DEVELOPMENT APPLICATION ASSESSMENT REPORT

PANEL REFERENCE	2018SCL002
FILE No.	DA617/2017/1
COUNCIL WARD	Double Bay
ZONING	B2 Local Centre
ADDRESS	28-34 Cross Street DOUBLE BAY
PROPOSAL	Demolition of the existing development and construction of a 6 storey mixed development with ground floor retail, 21 residential units over 5 levels and 2 levels of basement parking for 36 vehicles and 4 motorbikes with vehicular access via 20-26 Cross St
TYPE OF CONSENT	Integrated development
COST OF WORKS	\$25,428,904.00
DATE LODGED	14/12/2017 – Original submission 06/04/2018 – Replacement Application I 21/08/2018 – Replacement Application II
APPLICANT/OWNER	SJD DB2 Pty Ltd
ASSESSING OFFICER	Mr Dimitri Lukas
TEAM LEADER	Mr Thomass Wong
SUBMISSIONS	20
RECOMMENDATION	Approval

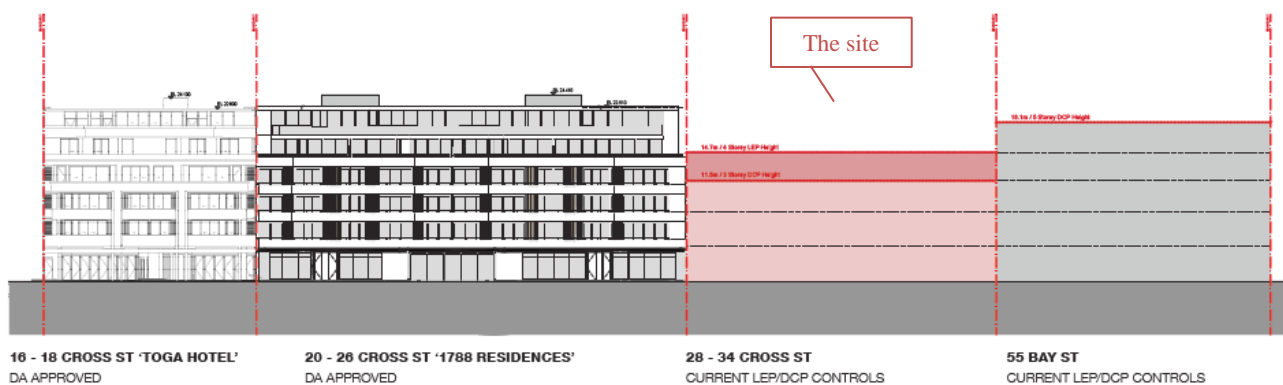
Urban Design Planner's comments: *The height of the proposal exceeds the 14.7m height appropriate to the existing or desired future character of the street and surrounding buildings as mapped in WLEP2014. The form and scale of the complying portion of the building (the lower 4 storeys) is appropriately aligned, proportioned and articulated. The proposal defines and forms public domain. However the top two levels which rise above the height limit do not conform to the desired future character of the location. Similarly the proposed building has an FSR of 3.5:1 which exceeds the control of 2.5:1. An exceedance that is equivalent to two levels.*

A compliant building form at 4 storeys in height would be contextually unsuitable given what has been approved immediately to its east and what is expected immediately to its west. A compliant development would appear like a “missing tooth” within Cross Street which is best depicted in the following schematic by BatesSmart Architects:

The built form and scale of the proposal is contextually suitable and compatible with recently approved and expected future developments in this locality.
